M-1977-410 AM2 Adequacy Review Response #3

RE: Cross Gold Mine, Permit No. M-1977-410, 110(2) Hard Rock Permit Amendment Application (AM-02), Adequacy Review No. 3

Grand Island Resources Cross Mine (M1977-410) Amendment #2 Response to DRMS Comments Dated December 29, 2021

EXHIBIT E - CROSS AND CARIBOU MINES RECLAMATION PLAN MAP: CARIBOU 300 AND POTOSI	
Project: CROSS AND CARIBOU MINE - AM 2 APPLICATION	Project No.: 21-1306
Location: NEDERLAND, COLORADO, USA	Date: JAN. 2022

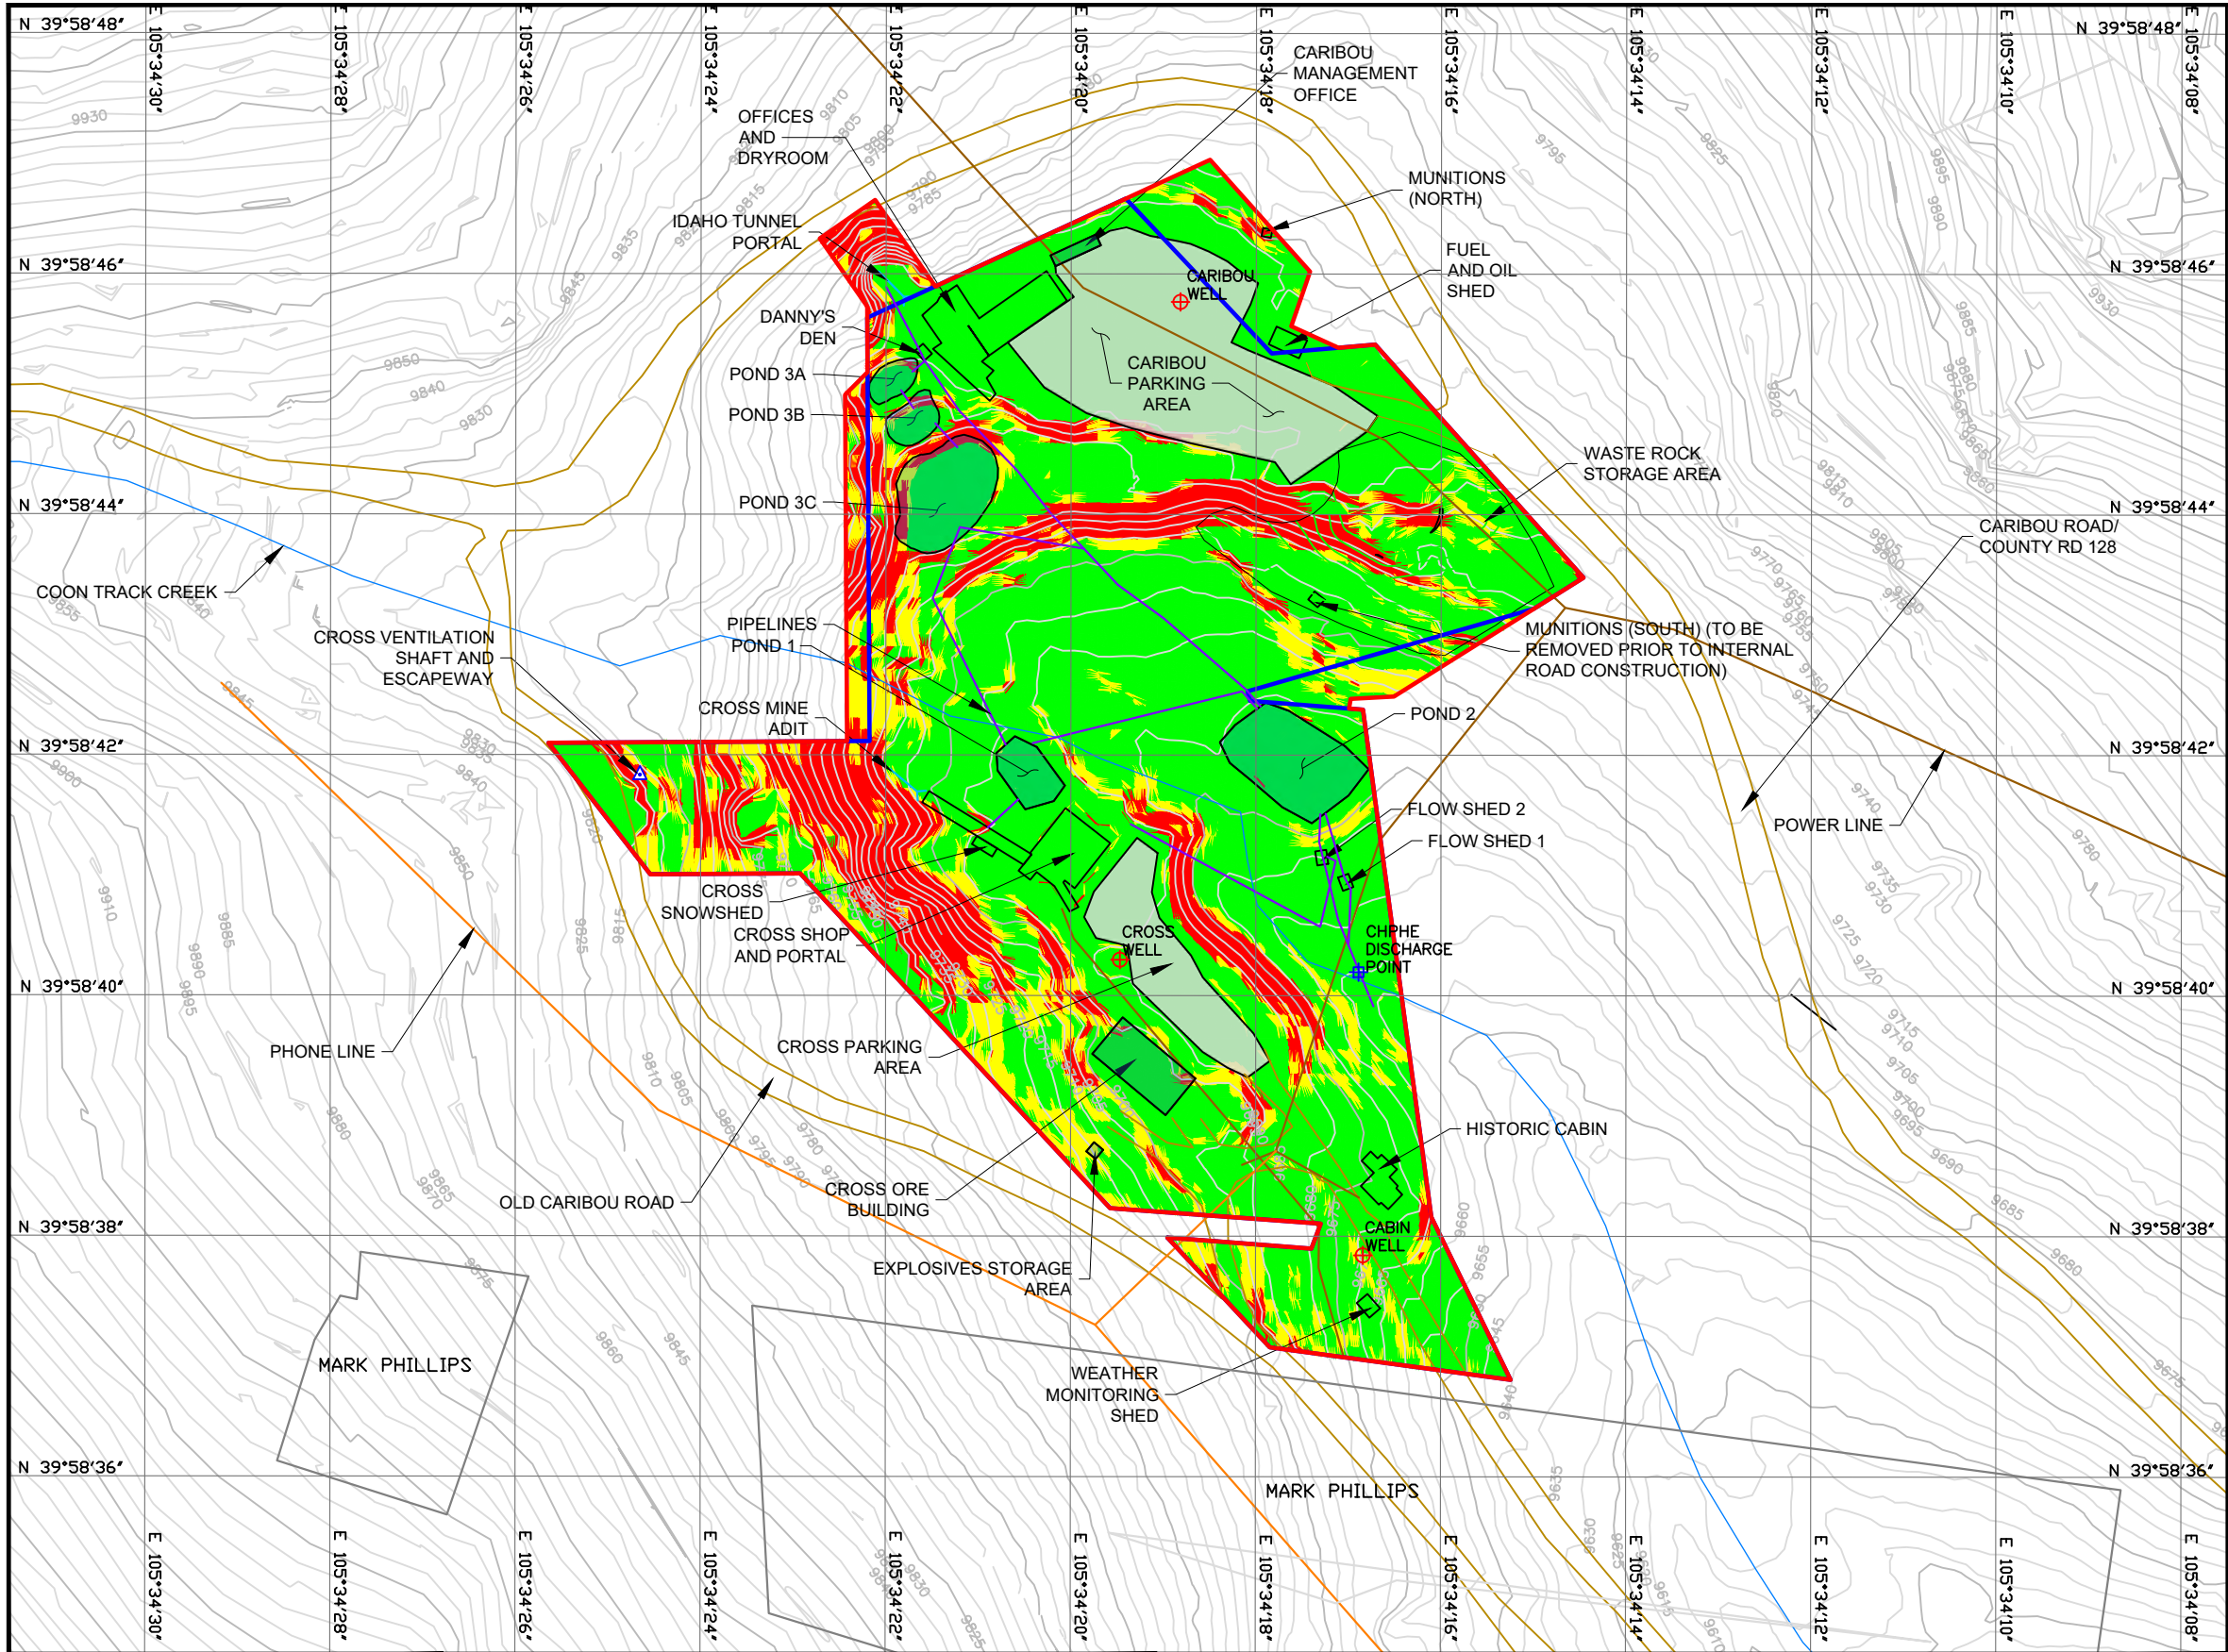
a. Please add “Exhibit E” to the map title.

b. The current map title is “Cross and Caribou Mine – General Facility Arrangement: Caribou 300 and Potosi”. However, the Division believes this is an error, as this map appears to be a reclamation plan map. Therefore, please change “General Facility Arrangement” to “Reclamation Plan Map”.

c. In the “Typical Top Soil Cover Detail, it shows that 24 inches of topsoil will be placed on reclaimed areas. However, the proposed reclamation plan indicates that 8-12 inches will be placed on the majority of the disturbed land, with 24 inches to be placed only on the waste rock storage area. If 24 inches of topsoil will be replaced on all disturbed lands, please be sure the reclamation plan is updated accordingly. Otherwise, please revise the Typical Top Soil Cover Detail on this map to reflect the actual proposed topsoil replacement depth for most disturbed areas.

d. The proposed reclamation plan includes three different seed mixes for the site (Tables 3 through 5). Please show the approximate locations on this map that will receive each of the proposed seed mixes.

e. The Caribou 300 Level Portal map includes a short access road off of Forest Service Road 505 (not included in the proposed permit area), which is shown to be reclaimed when mining concludes. As stated above, all proposed affected lands must be included within the proposed permit area, including any existing roads which will be substantially upgraded to support the mining operation, or new roads. Therefore, please remove this new road from consideration under AM-02 and modify this map accordingly. The road may be added into the permit area under a subsequent Amendment application.

- c. Please see renumbered Map 5 and revised text*
- d. Now shown on renumbered Map 8.*
- e. This road was removed from the map, tables, and text.*
